IFB No. 23-32 Security Vestibules at Ellis, Lewis Lemon, RESA & Marshall Schools

RE: ADDENDUM NO. 2

Subject: **CHANGES to the BIDDING DOCUMENTS**

Project: **SECURITY VESTIBULE AT
VARIOUS SCHOOLS FOR
ROCKFORD PUBLIC SCHOOL DISTRICT #205
ROCKFORD, ILLINOIS**

FIN TUBE RADIATION (FTR) SCHEDULE:

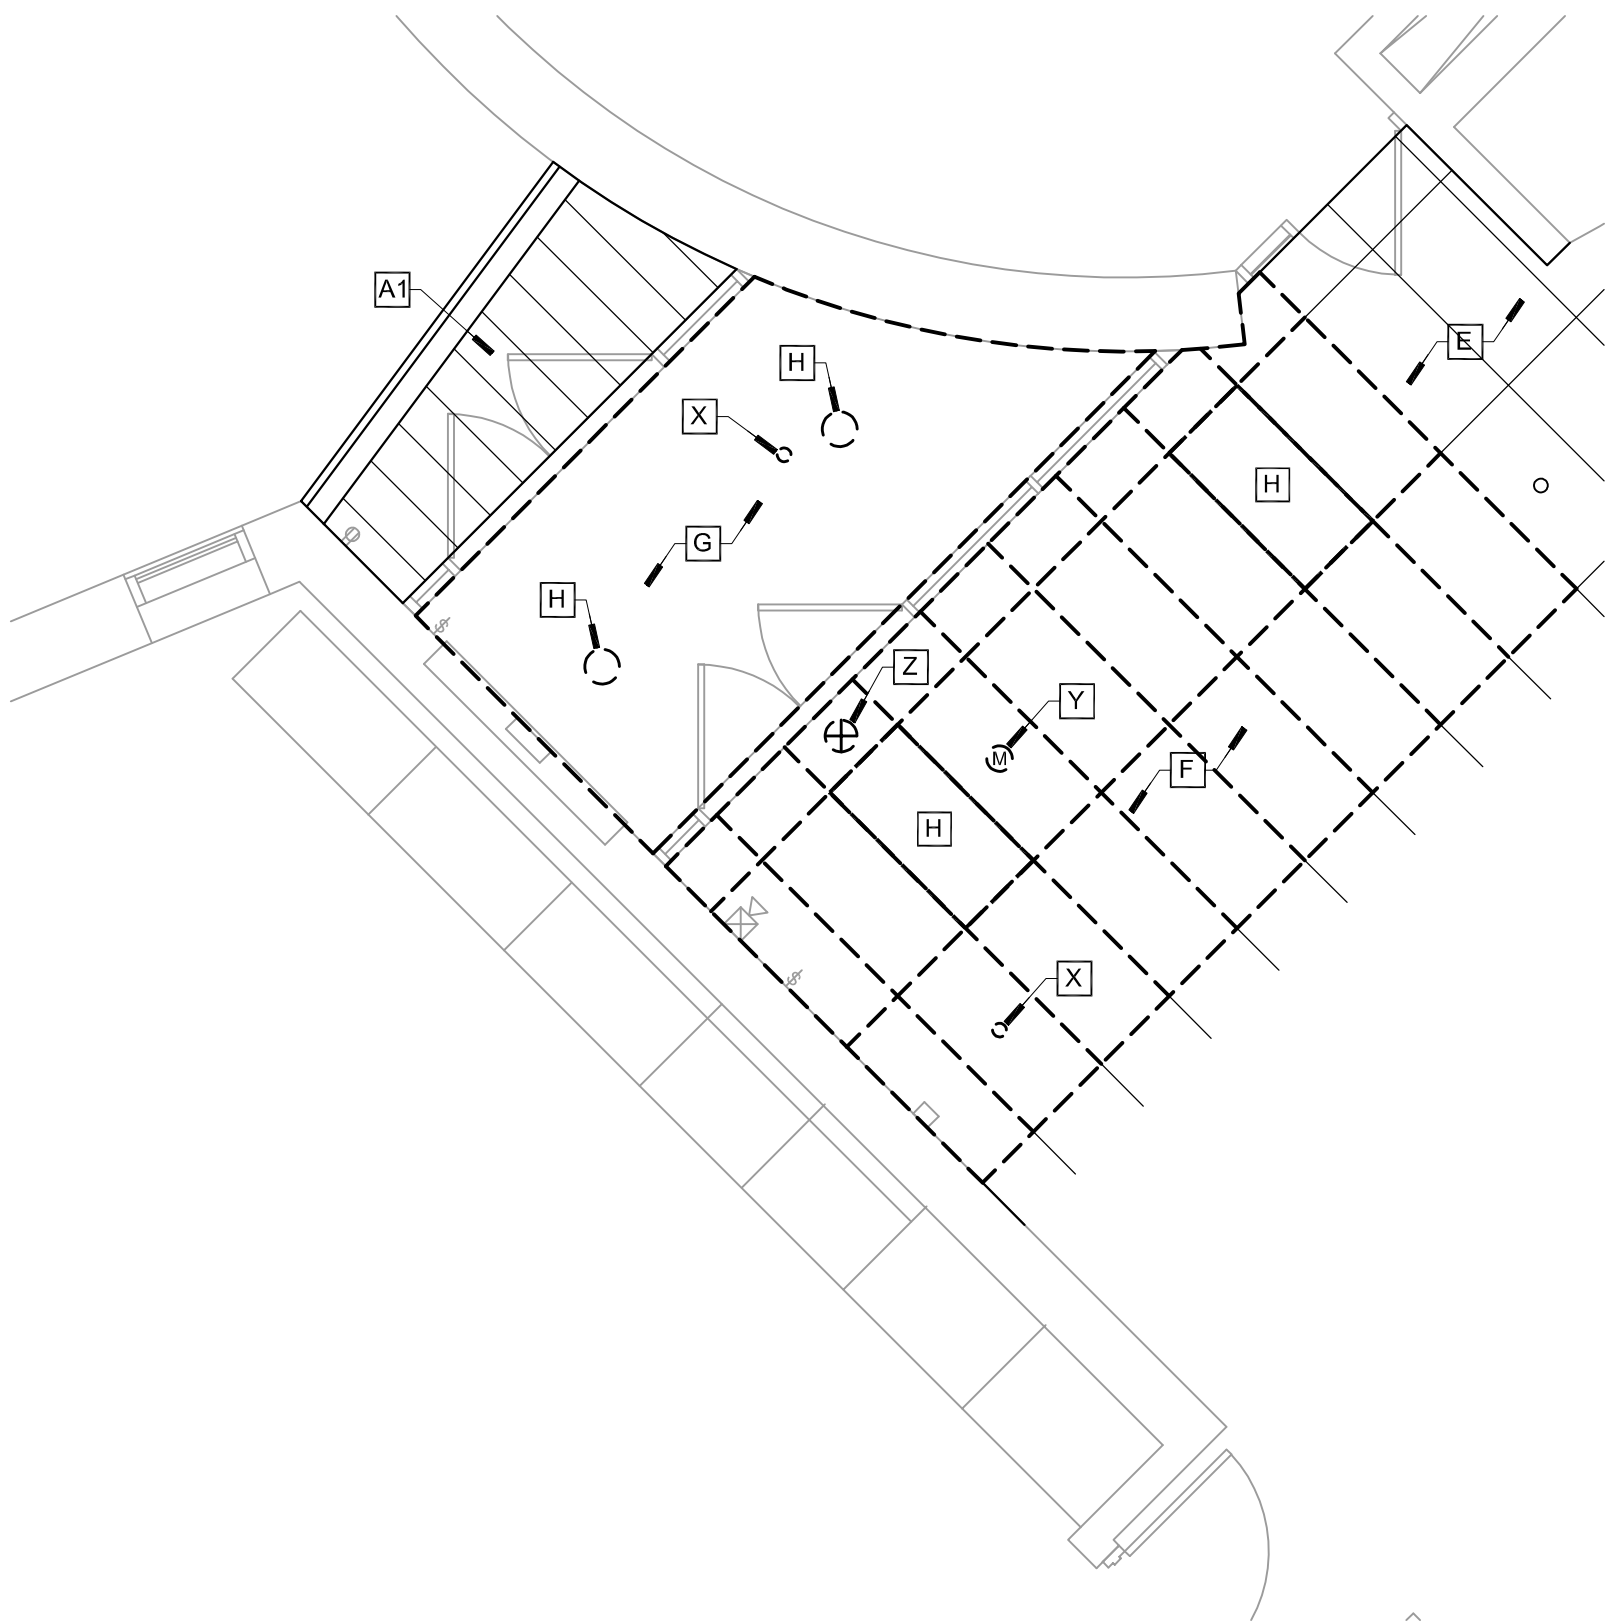
5. DRAWING M102

5.1. See attached Addendum Drawing ADM2.1 showing revised fin tube radiation schedule with updated manufacturer and model.

PLAN NO.	FTR-1	FTR-2
SERVICE	VESTIBULE L104	VESTIBULE L103
MANUFACTURER	VULCAN	MODINE
MODEL	JV4-ARPM	JV4-ARPM
TYPE	PEDESTAL-HOT WATER	PEDESTAL-HOT WATER
CAPACITY (BTU/H/FT)	980	980
FIN SIZE (IN)	4.25X4.25	4.25X4.25
ELEMENT LENGTH (IN)	60	60
ENCLOSURE LENGTH (IN)	72	72
ROWS	1	1
EWI (DEG. F.)	180	180
PIPE SIZE (IN)	3/4"	3/4"
FIN SPACING (FINS/FT)	50	50
NOTES	1-5	1-5

**PARTIAL DEMOLITION
PLANS**

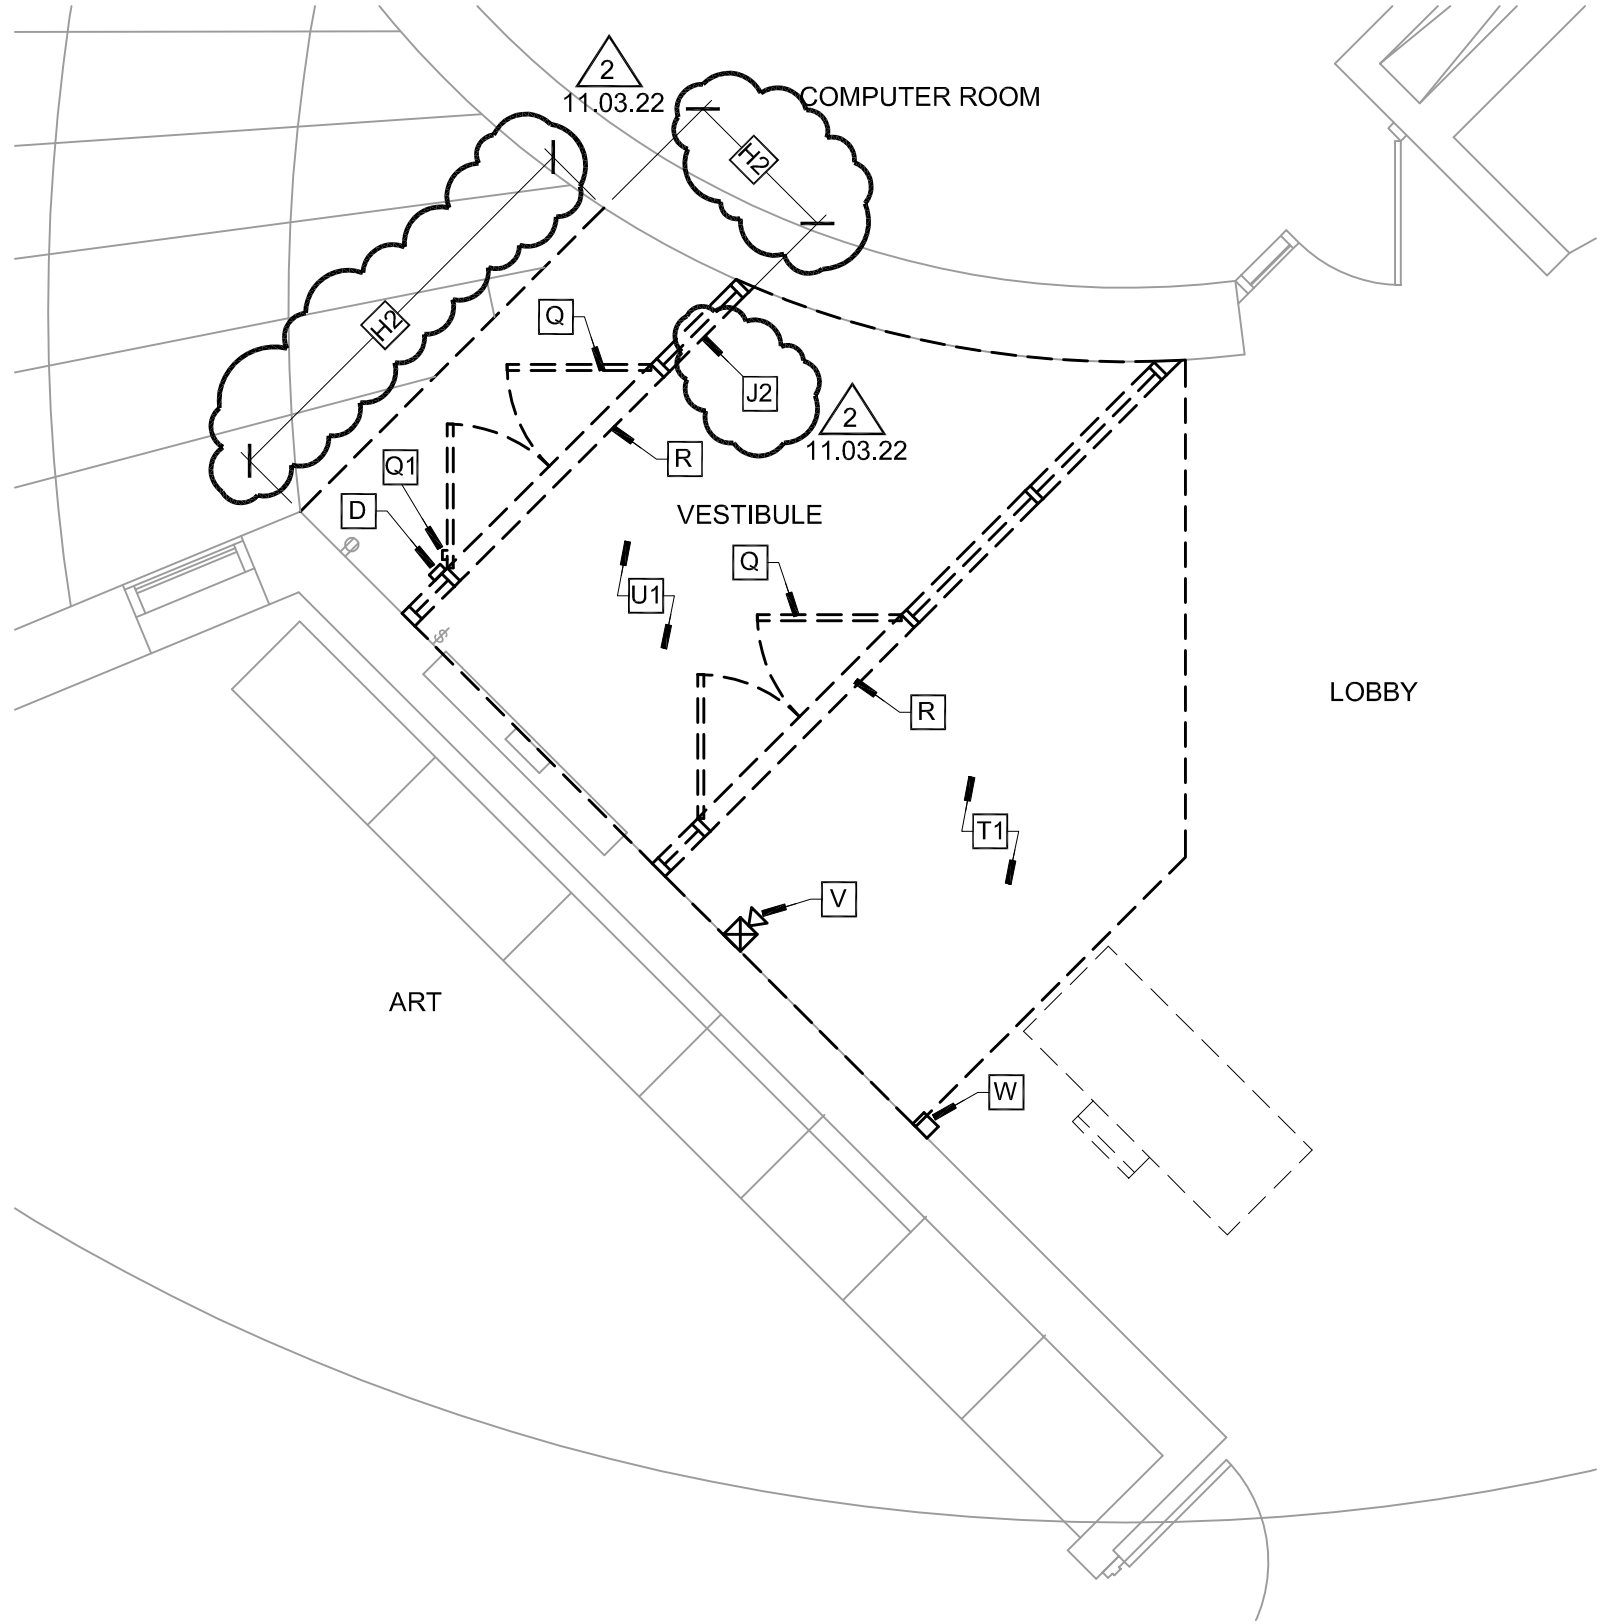
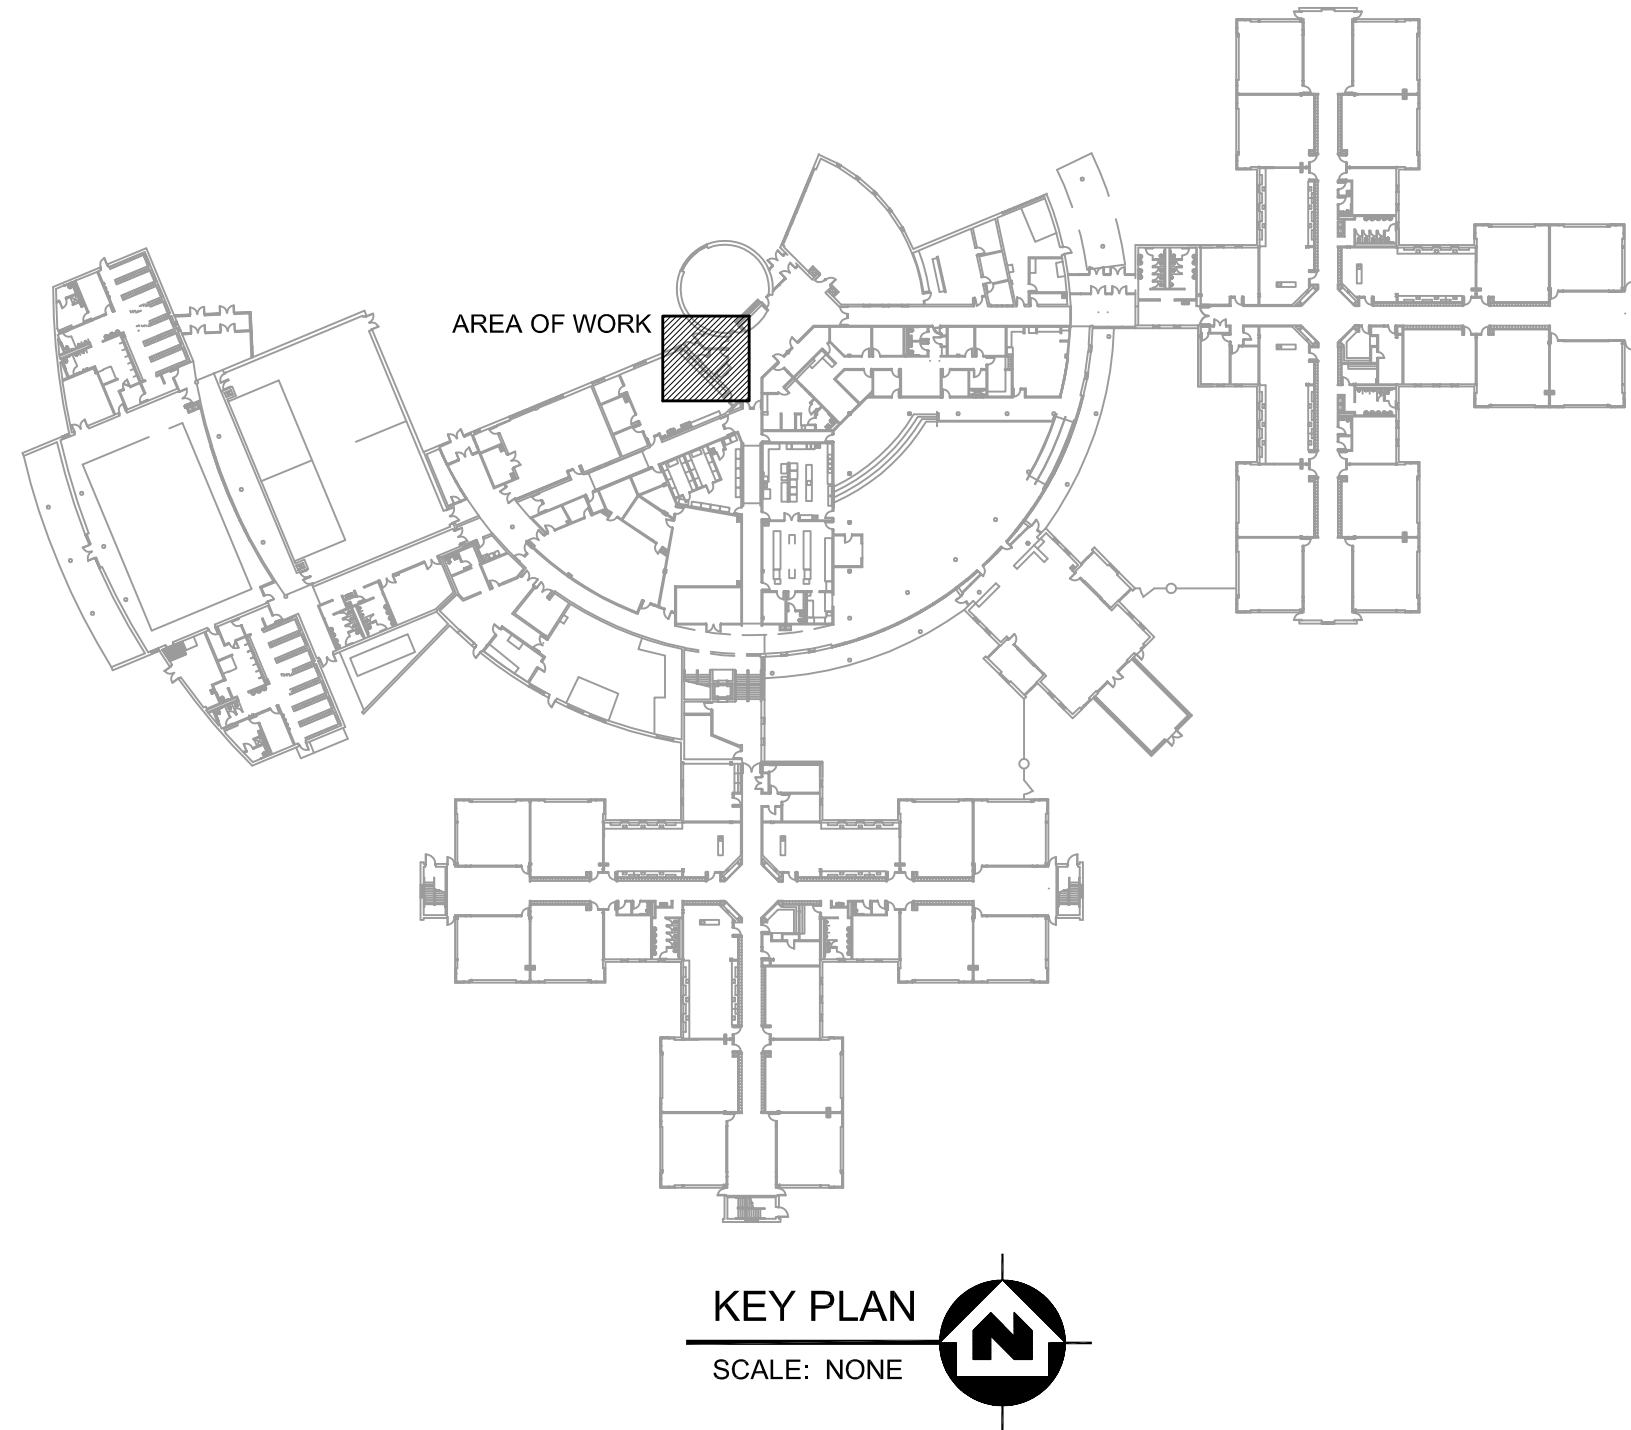
1. DRAWING A108

1.1. Existing concrete stoop top to be removed and replaced. See attached revised drawing.

- [G2] REMOVE EXISTING CARPET, RUBBER BASE AND TRANSITION STRIPS.
- [H2] REMOVE EXISTING CONCRETE STOOP TOP, FOUNDATIONS TO REMAIN
- [J2] SAWCUT EXISTING SLAB AS REQUIRED

3 PARTIAL REVISED STOOP PLAN

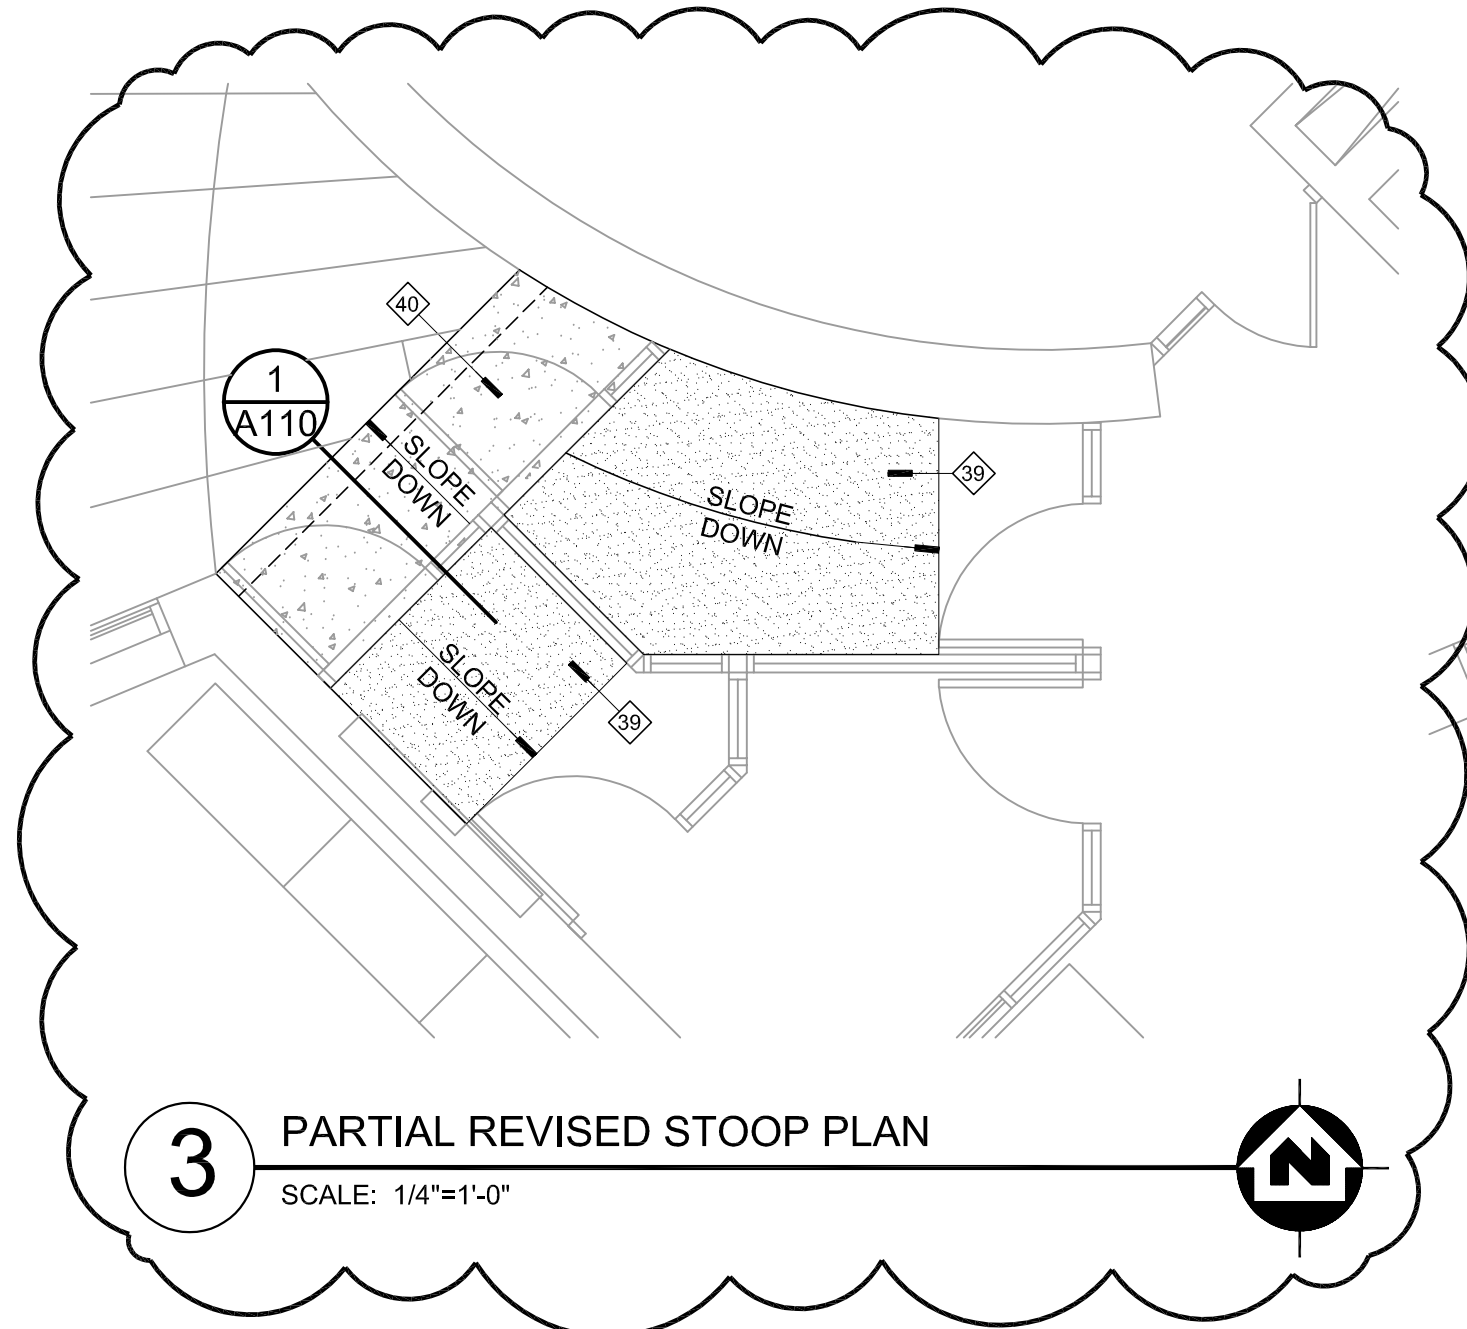
2. DRAWING A109

2.1. See added plan 3 showing the new concrete stoop top and skim coat topping required to raise the threshold of the door by ½". See attached revised drawing.

- 38 INSTALL NEW CARPET, RUBBER BASE AND TRANSITION STRIPS.
- 39 AFTER INSTALLATION OF ALL ALUMINUM FRAMING - PROVIDE SKIM COAT TOPPING AS REQUIRED TO GRADUALLY SLOPE FROM ENTRY DOOR @ ELEV. +0-1/2" DOWN TO 3'-0" IN FRONT OF INTERIOR DOOR @ ELEV. 0'-0"

- 40 NEW 4" THICK CONCRETE TOPPING WITH WELDED WIRE REINFORCEMENT PER ASTM A1064 - TIE INTO EXISTING FOUNDATIONS - SEE DETAIL 3/A110
- 41 SEE PLAN 3/A109 FOR PARTIAL REVISED STOOP PLAN
